March 6, 2015

**RE: Adjustment to Existing Easterly Boundary of PRC 3242.1**

Attached:      **Attachment 1:** List of Revisions made to the Project Description – “Adjustment to Existing Easterly Boundary of PRC 3242.1” submitted by Venoco, Inc on June 30, 2014.

**Attachment 2:** Revised Figures

1: Figure 1.4-1 Location Map

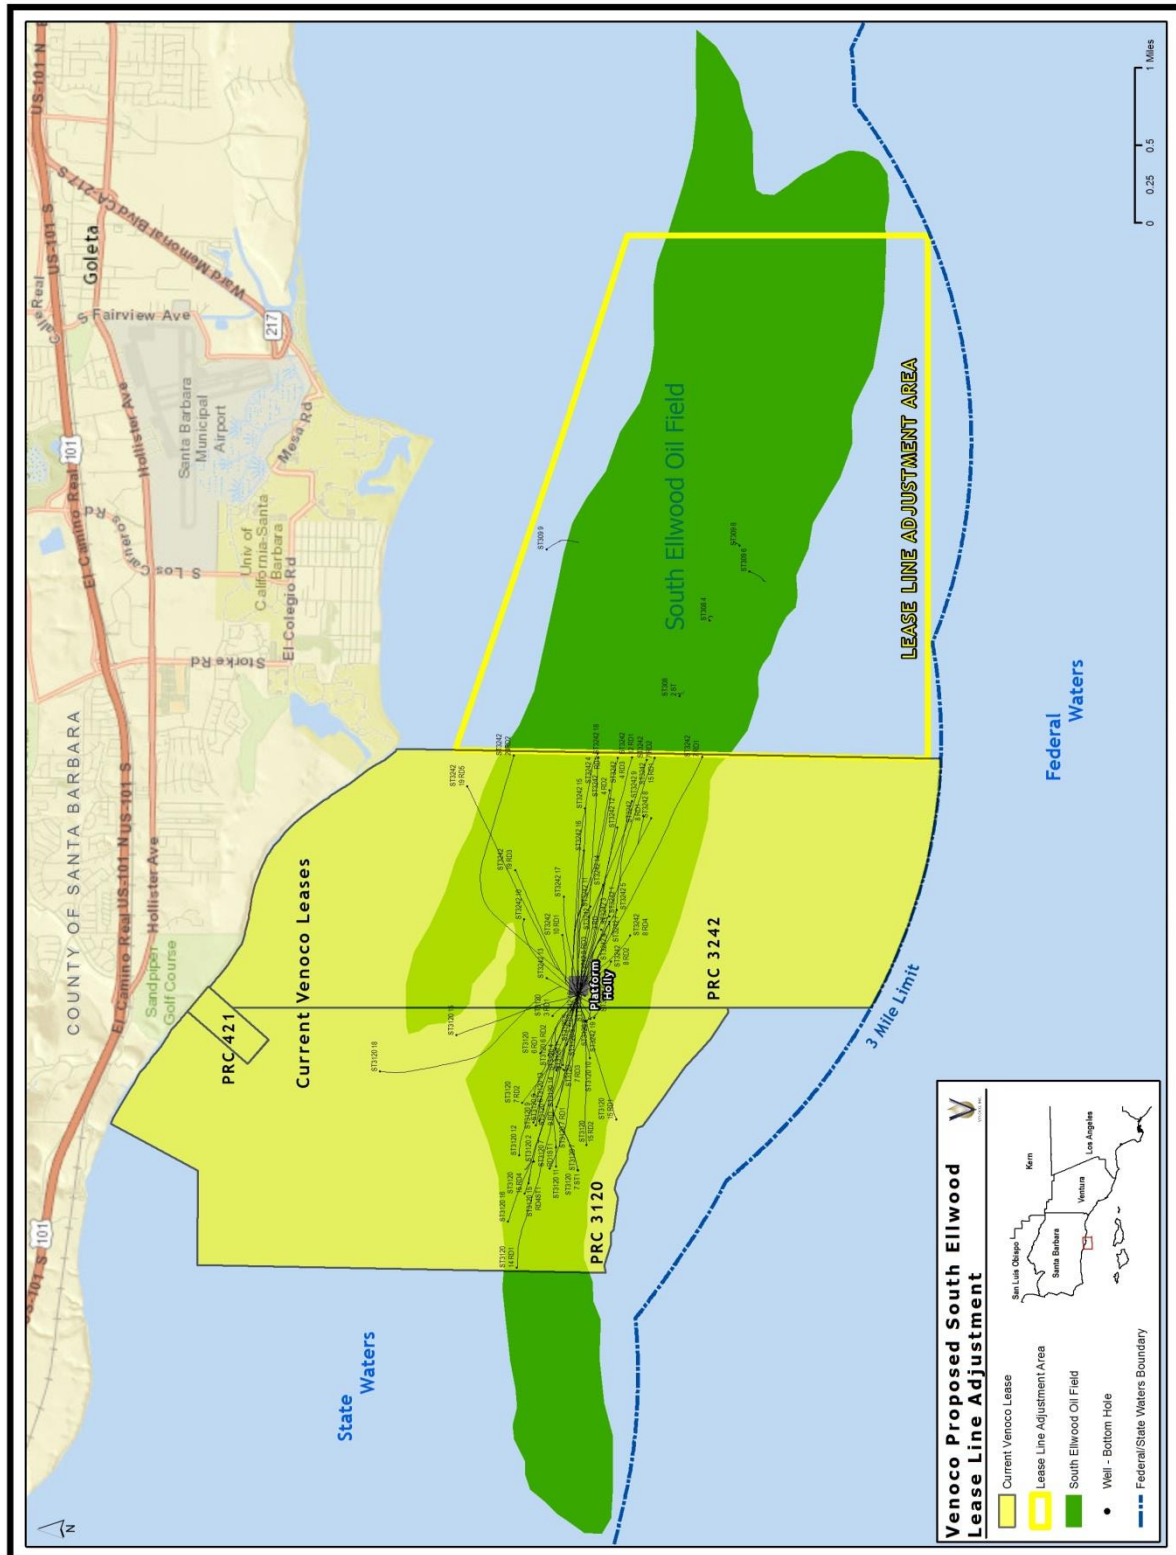
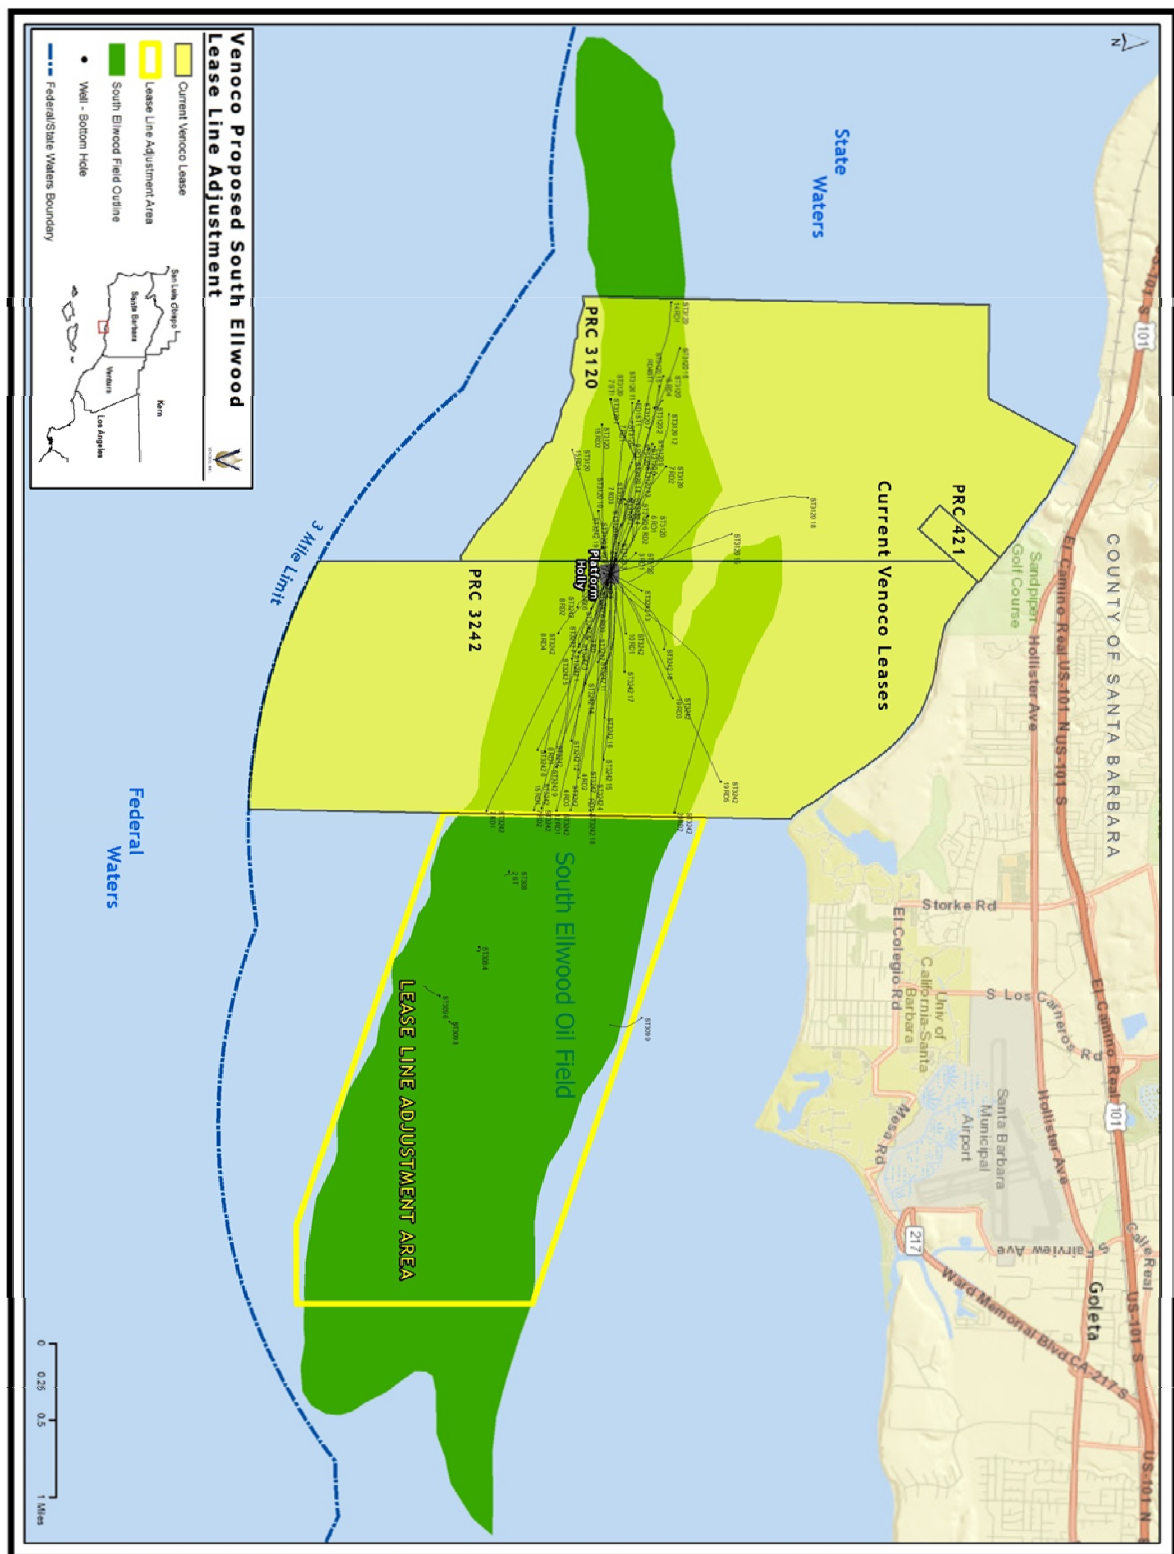
- 2) Page 2 (Figure 1.4-1): Replace with new Location Map showing revised lease adjustment boundary.
- 3) Page 5 (Figure 2.1-1): Replace with new Structure-Contour Map showing revised lease adjustment boundary.
- 4) Page 8 (Section 2.2, Paragraph 1): Replace entire paragraph 1 with the paragraph below; insert new Figure 2.2-1 :

**5: Figure 3.2-1 Proposed lease Line Adjustment**

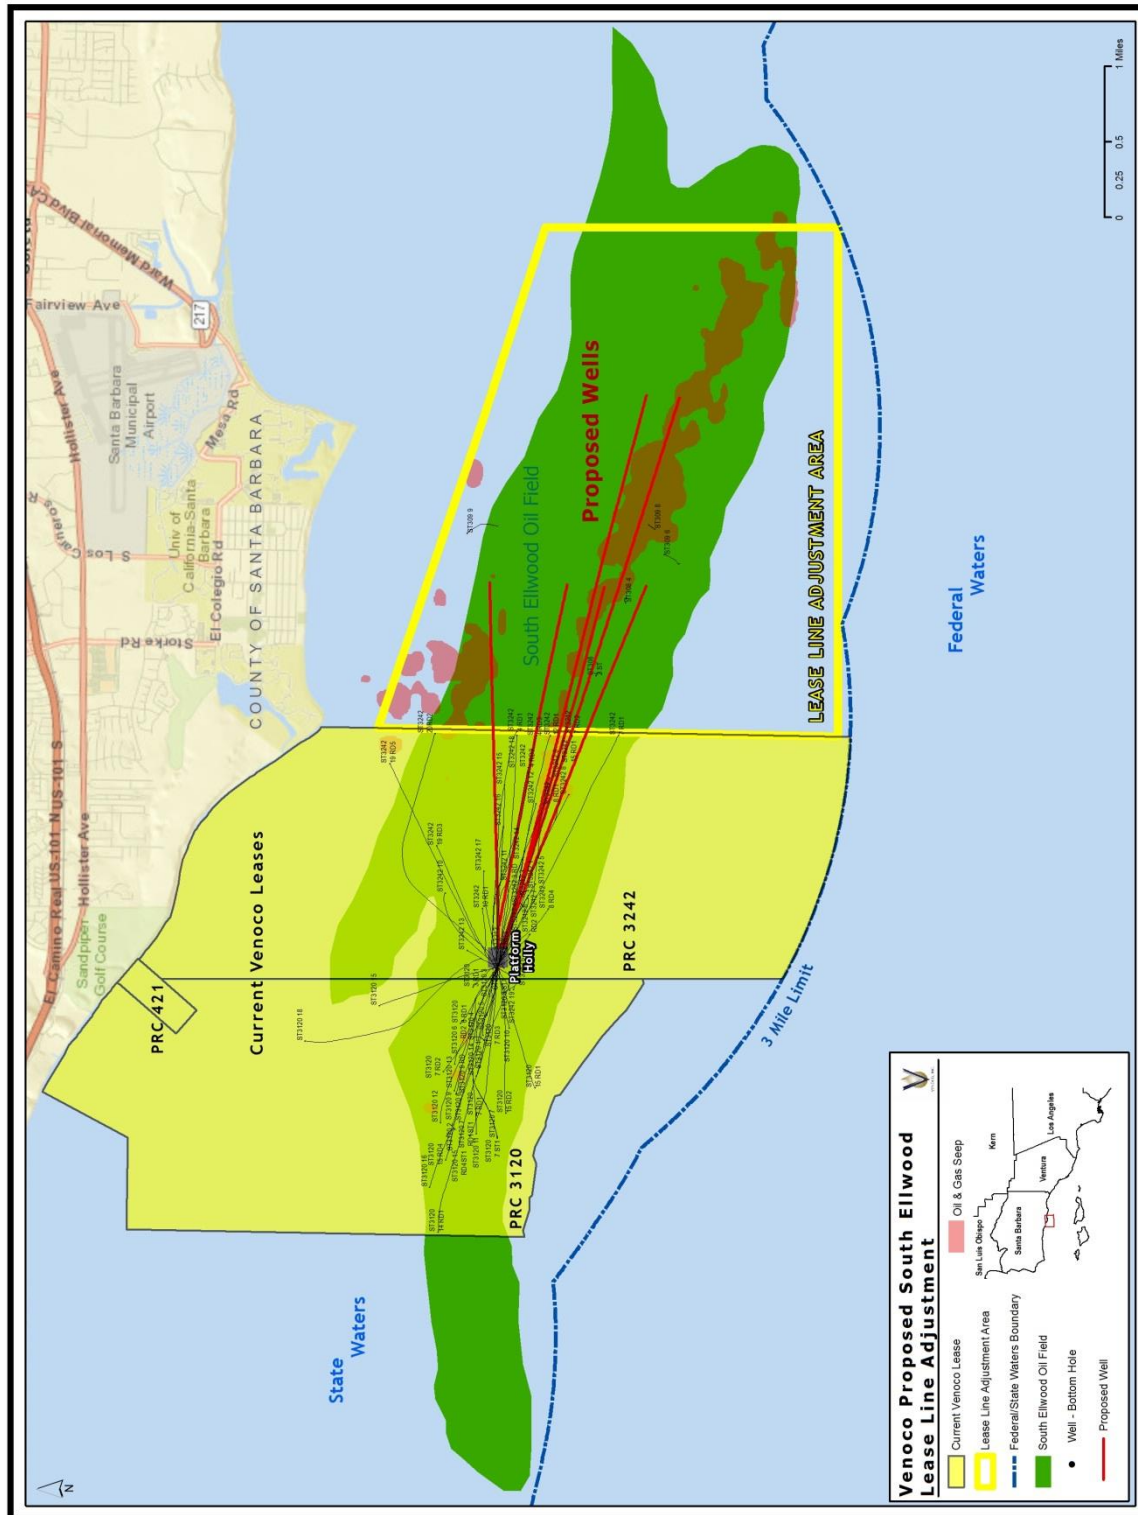
- 6) Page 11 (Figure 3.2-1): Replace with new Proposed Lease Line Adjustment Figure.
- 7) Page 21 (Section 3.4.1): Change Title of Section to “Adjustment of Existing Leases”. Replace entire section 3.4.1 (legal description) with text below:
